December 27, 1991

TO: CASI Board of Directors

From: Bob Whitefield

Subject: Rancho CASI Site Improvements

# 2

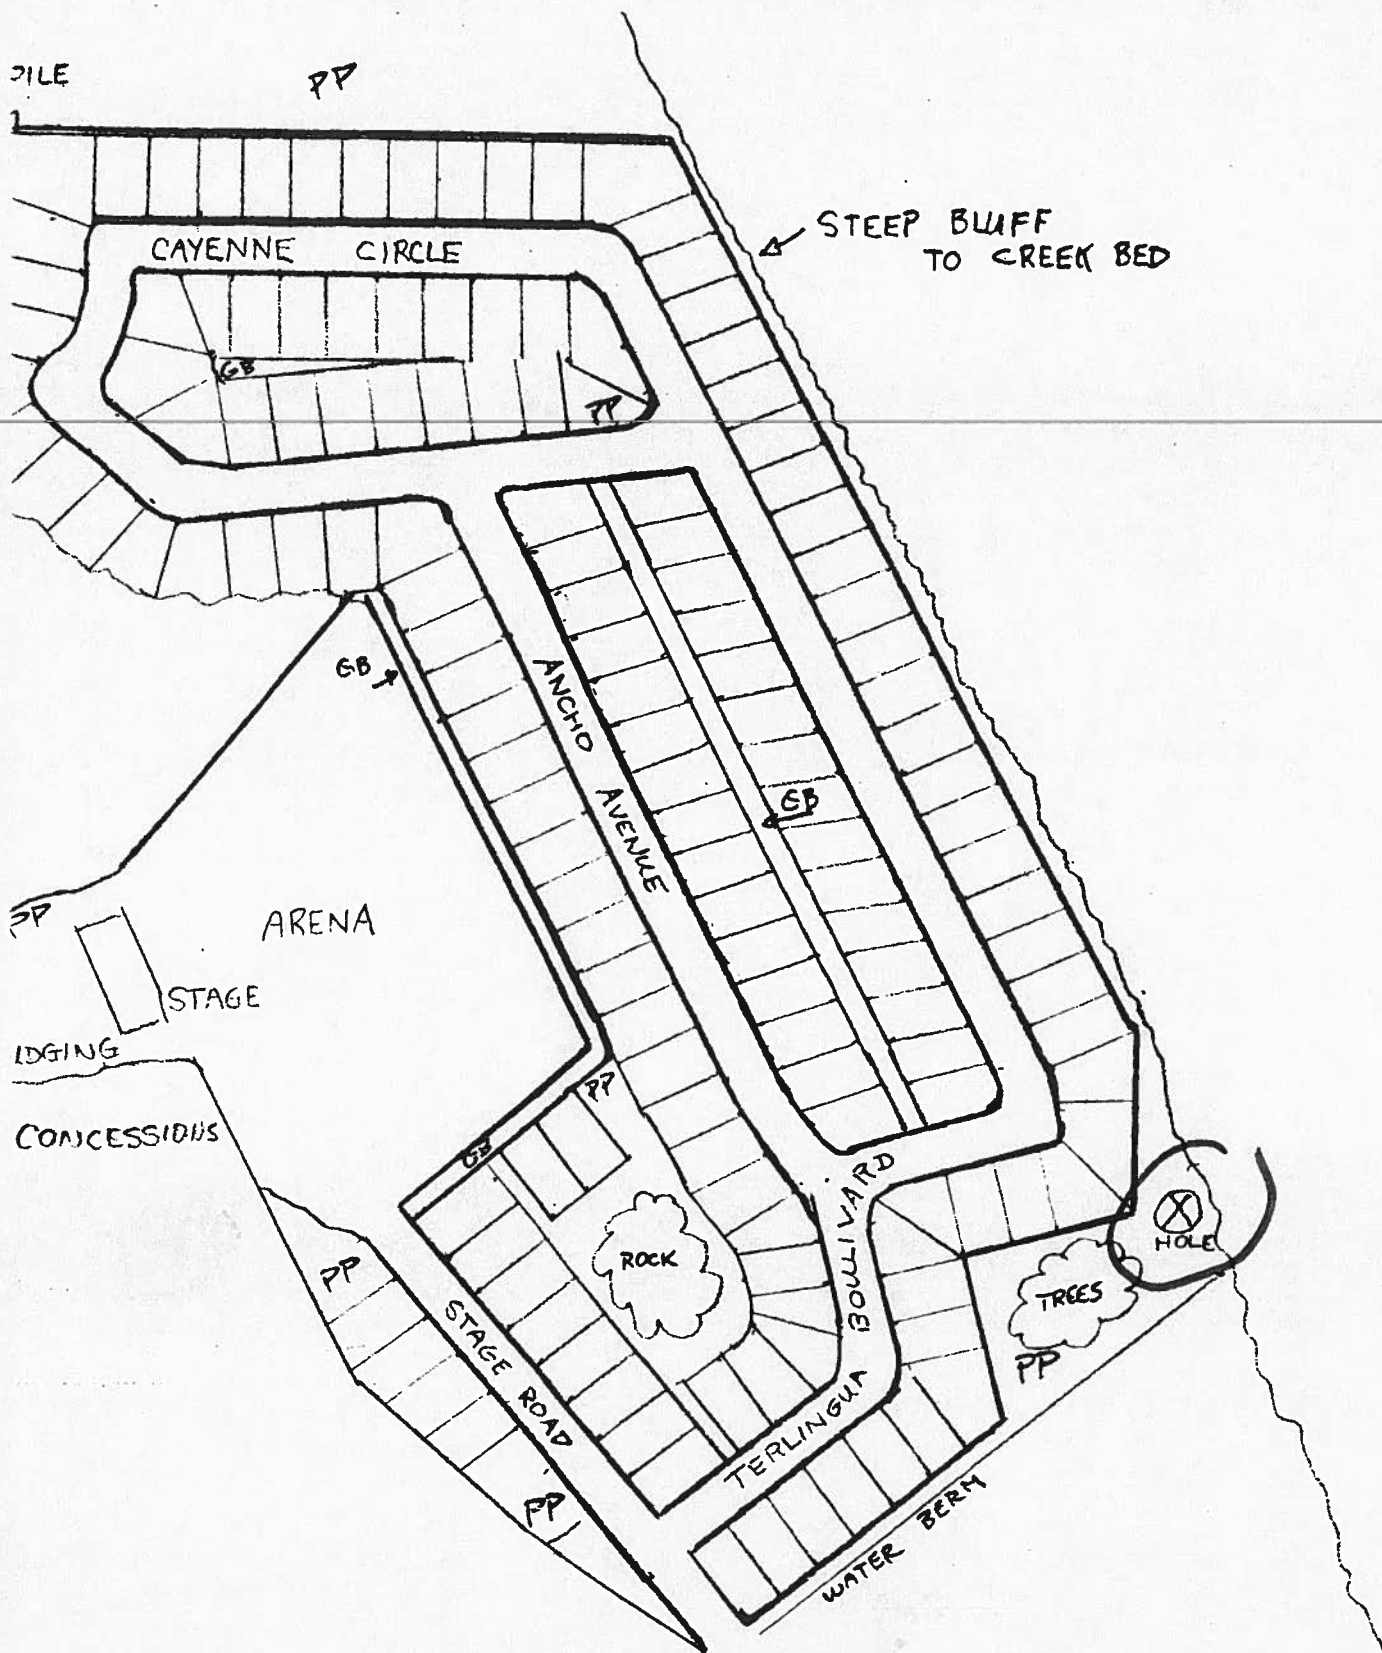
If you look at drawings 1, 2, and 3 you can see the area labeled

"HOLE" which is circled in red. Drawing 3 has this area called "TREED SITE FOR PORTA POTTIES" and its dimensions of 88' X 88' underlined. This entire area should be left alone. Drawing 4 shows the length of the water berm from Stage Road to the edge of the dropoff to the creek bed is 304'. Drawing 3 shows the distance from Stage Road to the beginning of the "TREED SITE..." is 175'. Therefore, when we move the berm out to its new location we can take only that first 175' and no more. We cannot take out any of the "TREED" area or we'll be asking for big trouble.

# 1

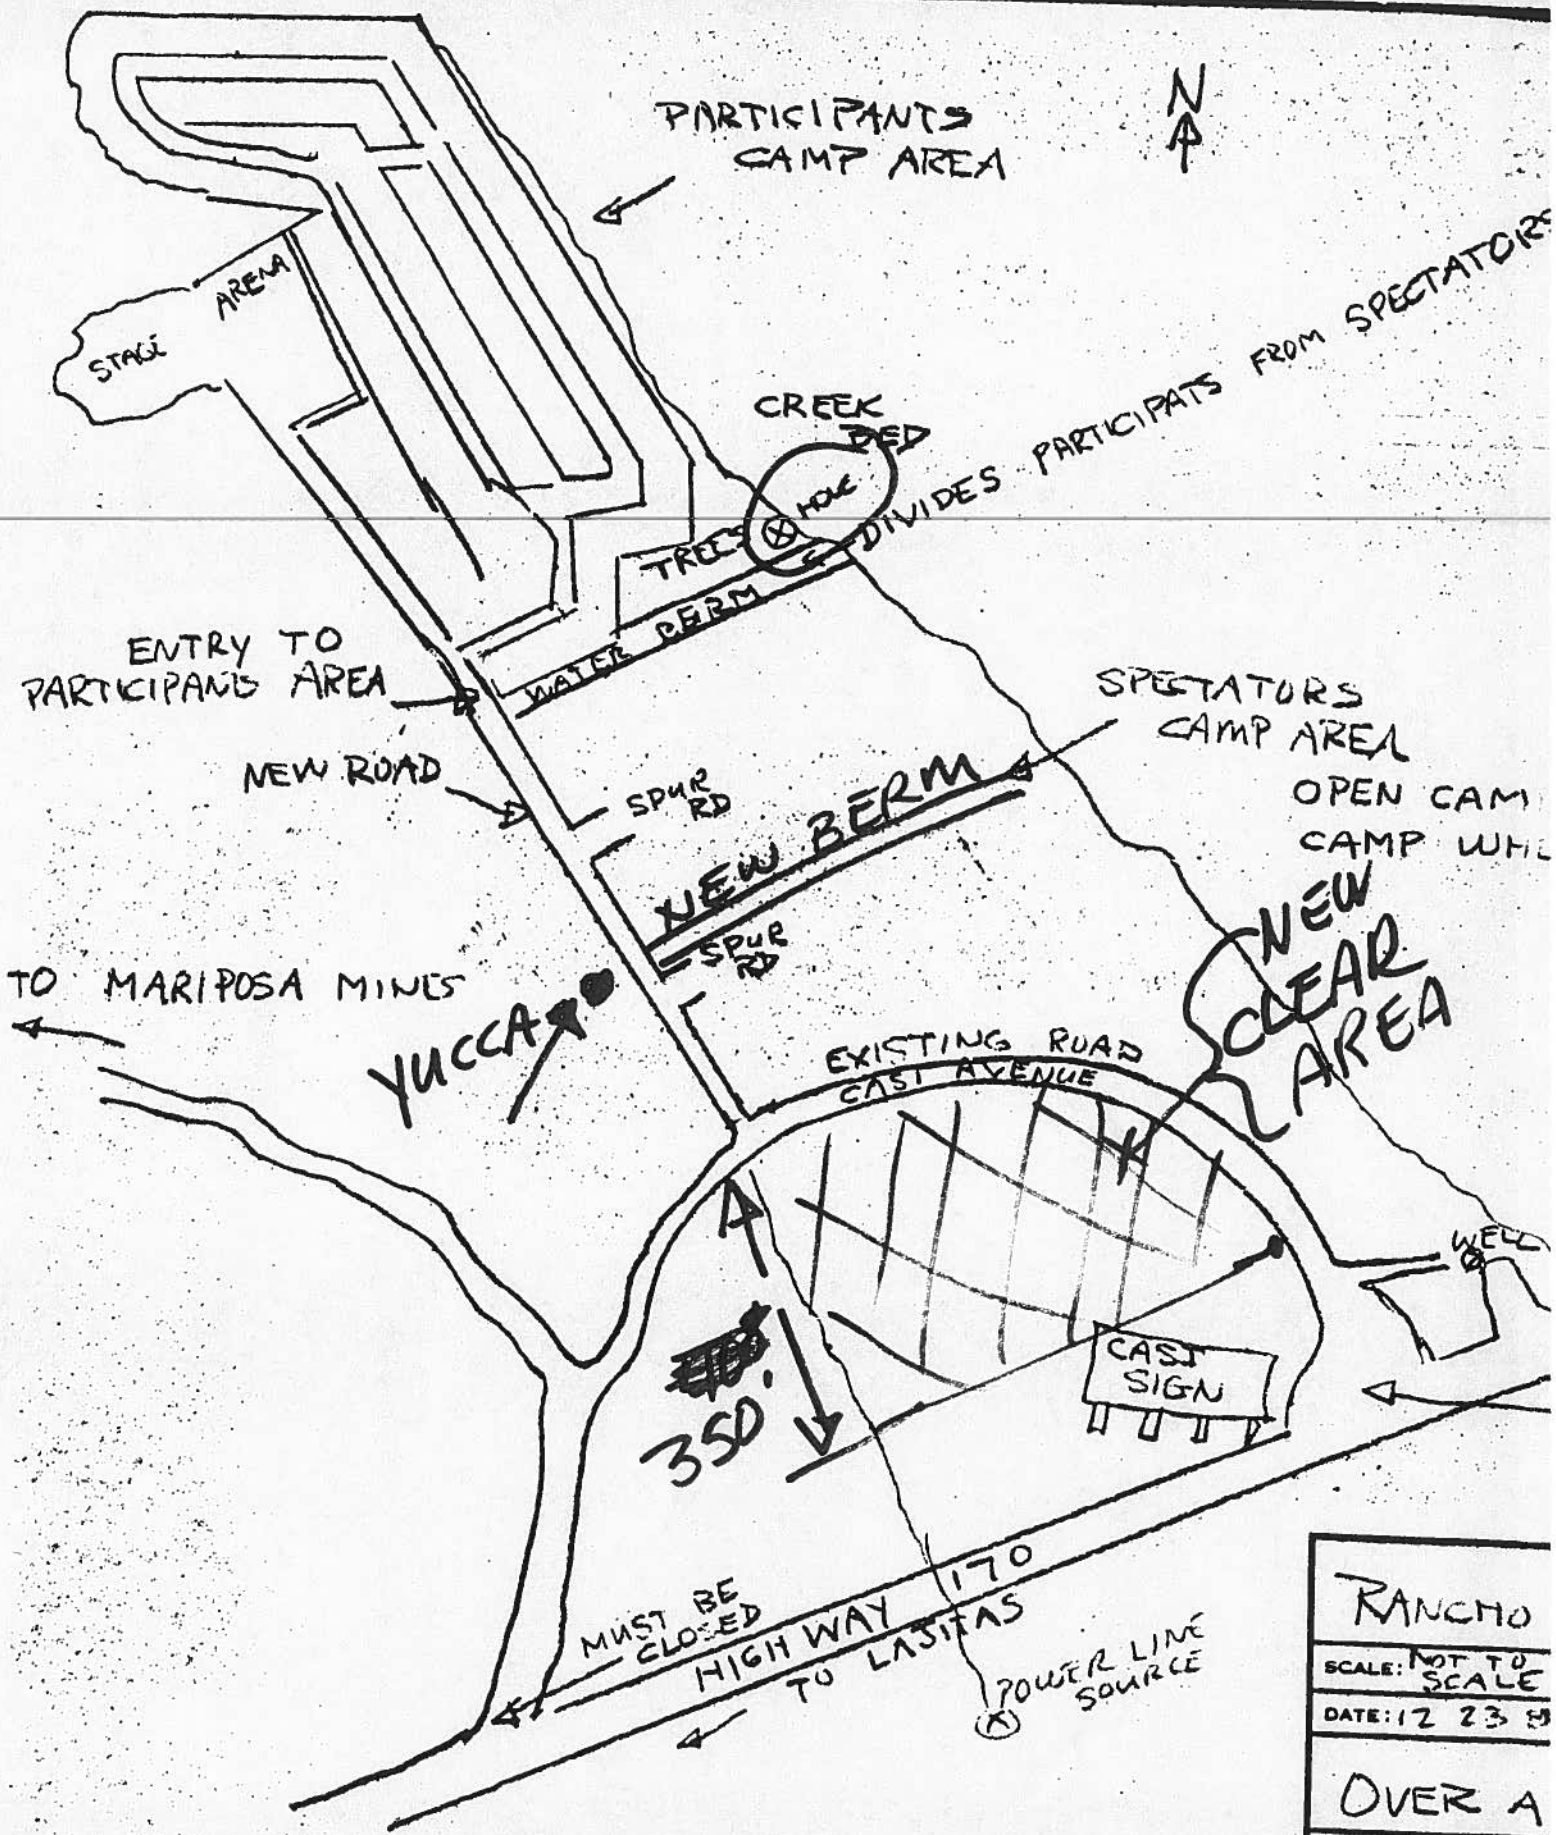
The second issue of Vanns' is that he is not clear where the new berm is to be located, and how far across CASI Avenue is to be cleared for the new spectators area. Drawing 1 has a red dot that shows the approximate location of a yucca that is standing along side Stage Road. It stands out very prominently and is the only one along the road. Vann can't miss it. This is the line where we all agreed we should move the berm to.

Drawing 1 also shows how much should be cleared across CASI Avenue.

- a. We remove only the first 175' of the berm.
- b. We leave the "TREED" area alone.
- c. The new berm should be created from the area opposite the yucca along Stage Road extending easterly to the edge of the cliff that drops to the creek bed.
- d. The new spectator area be cleared, leaving appropriate attractive vegetation, in an area 350' from the intersection of Stage Road and CASI Avenue southward along the hill where our CASI sign is, eastward from there to CASI Avenue, as shown on Drawing 1.
